**RE: ARCHITECT CONSULTANT SECOND REVIEW**

THE A. CHAUBE RESIDENCE, 14300 Lora Drive, Los Gatos, CA 95032

**ITEM: 14300 Lora Drive**

Architecture and Site Application S-20-019

**1. MASS BULK AND SCALE, SOLAR, PRIVACY CONCERNS.**

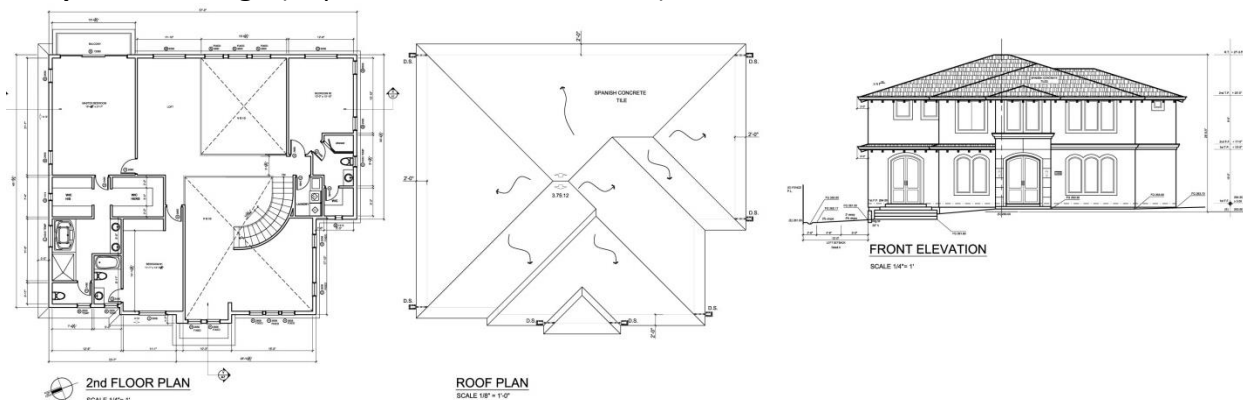
- The overall height has been reduced by 3'-8.5" by lowering the foundation, First Floor Finish level, and roof pitch.
- Left side of L2 is setback by 4' to provide privacy and visual relief to the left neighbor at 14298 Lora Dr.
- The second floor has been reoriented to provide additional privacy to the left neighbor.
- Balcony has been positioned to the right side, increasing the distance from the left neighbor.
- Voids have been reduced by 254sf (30% reduction in size).
- All around roof between the 1st and 2nd floor has been introduced to accommodate neighbors concern about the continuous solid wall as well as privacy concern.
- Portion of 2nd floor rear elevation is setback around the void and loft area to break the continuous wall and to further reduce roof height.
- The proposed 4,467 sf. is still under the limit of Town of Los Gatos ordinance (max. limit 4,590 sf.).

**SOLAR & SHADOW**

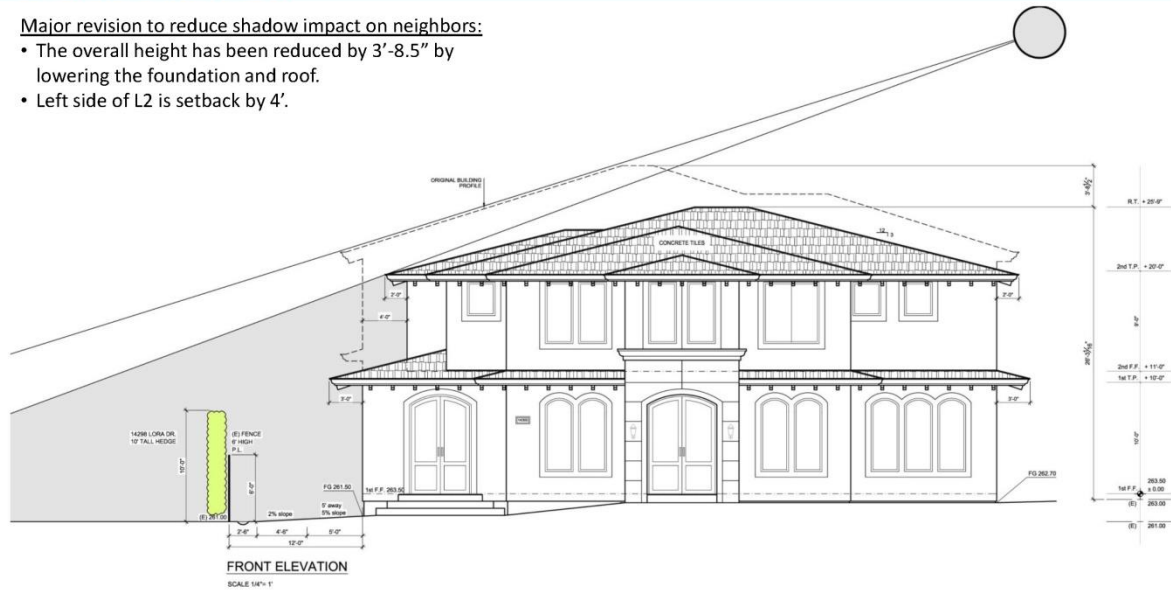
Major revision to reduce shadow impact on neighbors:

- The overall height has been reduced by 3'-8.5" by lowering the foundation and roof.
- Left side of L2 is setback by 4'.
